ORIGINATION FORM

Proposed Revisions to a Standard Plans Index
(Please provide all information — Incomplete forms will be returned)

Index Number: 521-610
Sheet Number (s): 1
Index Title: Concrete Barrier/Junction Slab - Wall Coping

Summary of the changes:

REVISION	DESCRIPTION	FY 2021-22	CONCRETE BARRIER/JUNCTION SLAB	INDEX	SHEET
11/01/20		STANDARD PLANS	- WALL COPING	521-610	1 of 3

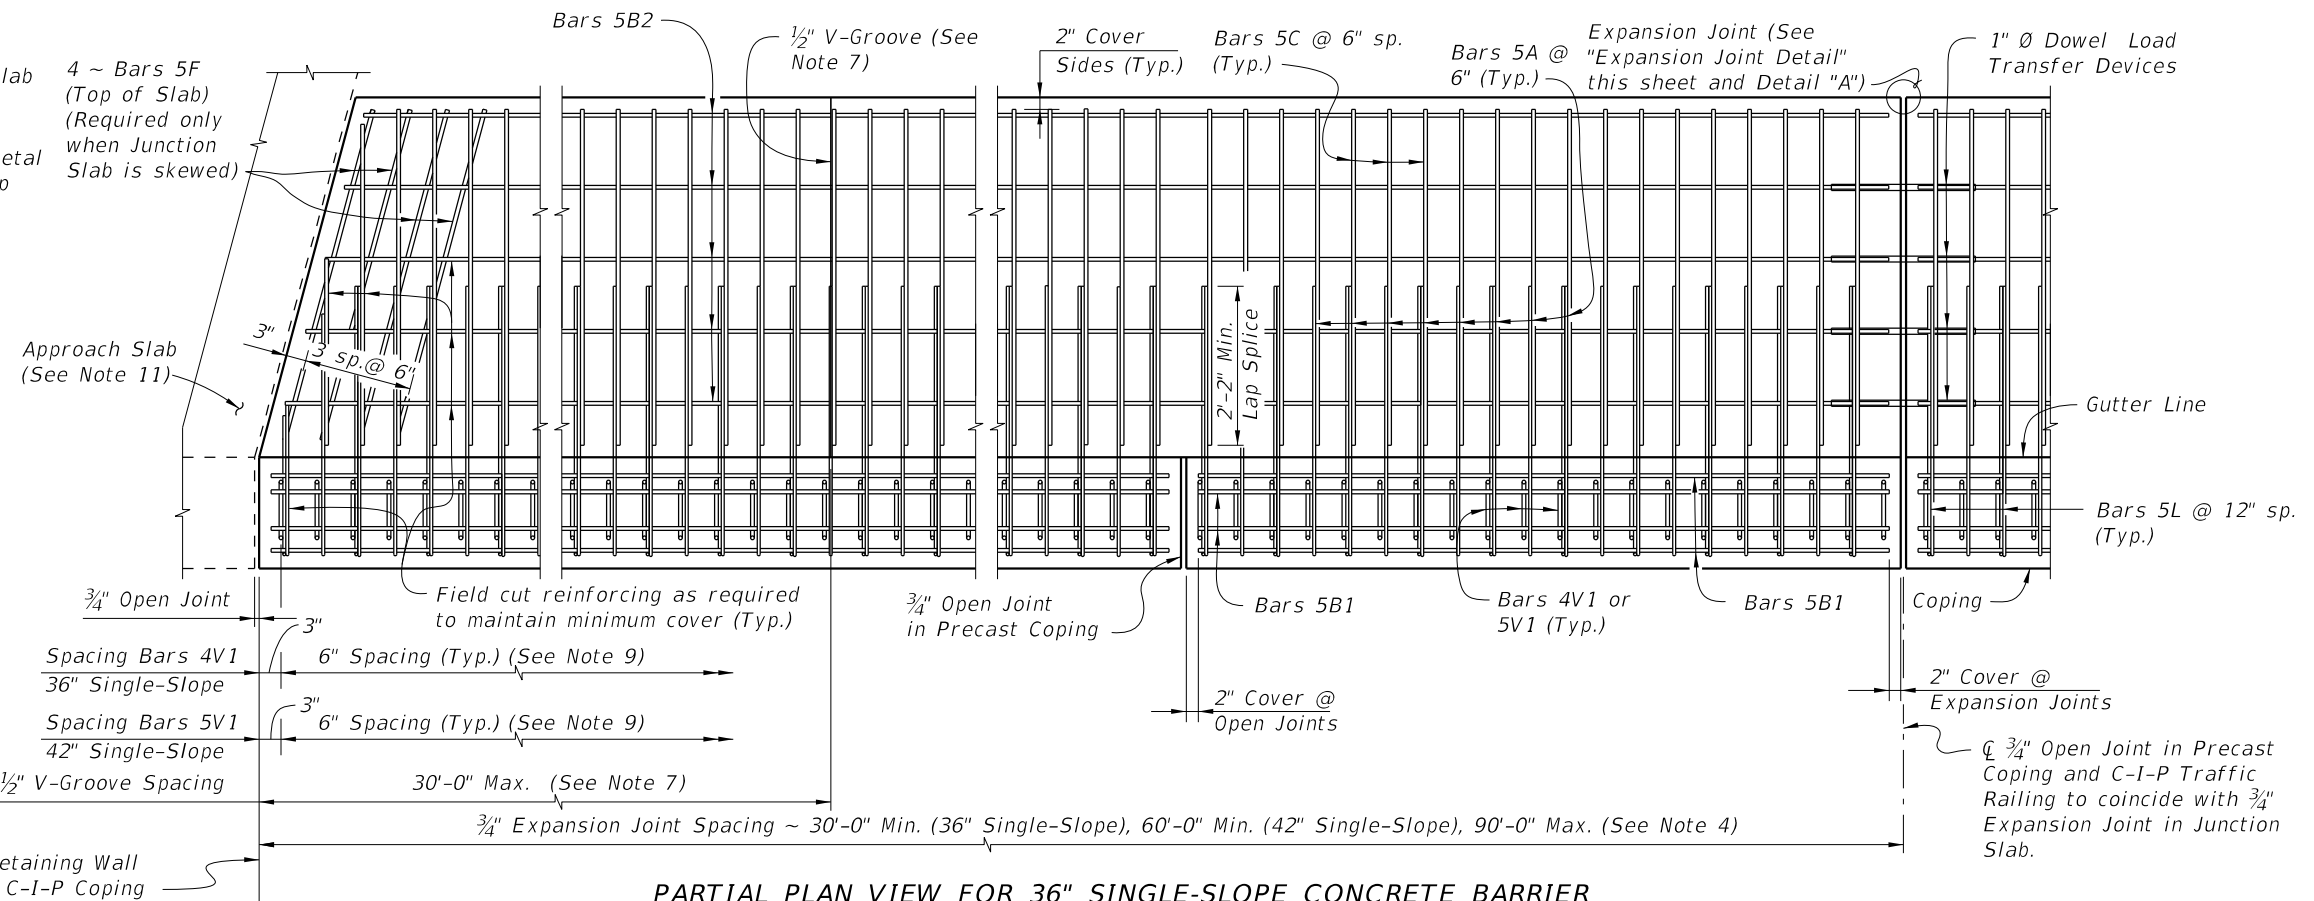
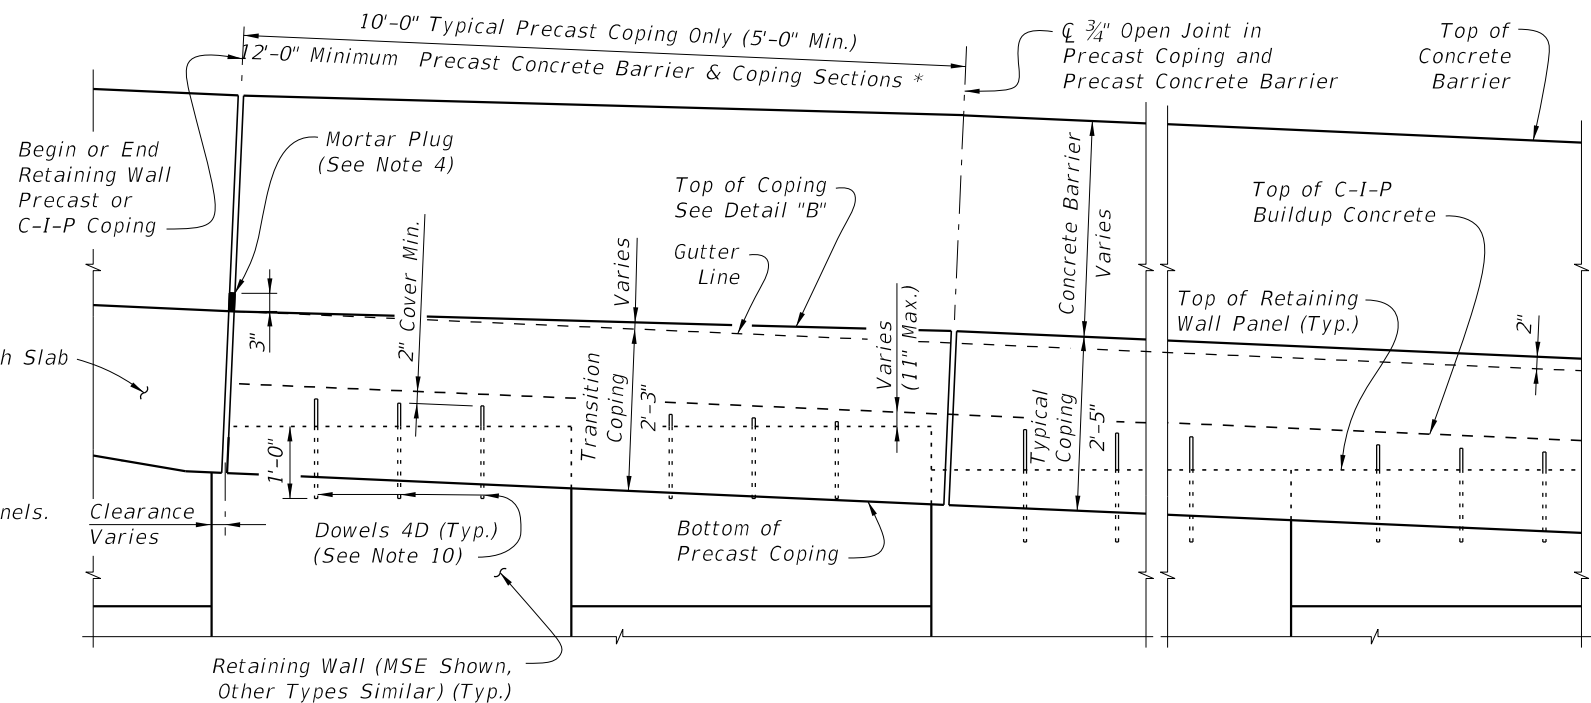
Sheet 1, Note 15: Added reference to Index 630-001 (Conduit Details - Embedded) for information on embedded junction boxes and conduits.

Added reference to provide continuity between Standards and improve understanding for designers and contractors wanting to verify that these Indexes share details. This particular topic received designer questions. This is consistent with the Traffic Railing standards.

15. For embedded conduit and junction boxes, see Index 630-010.
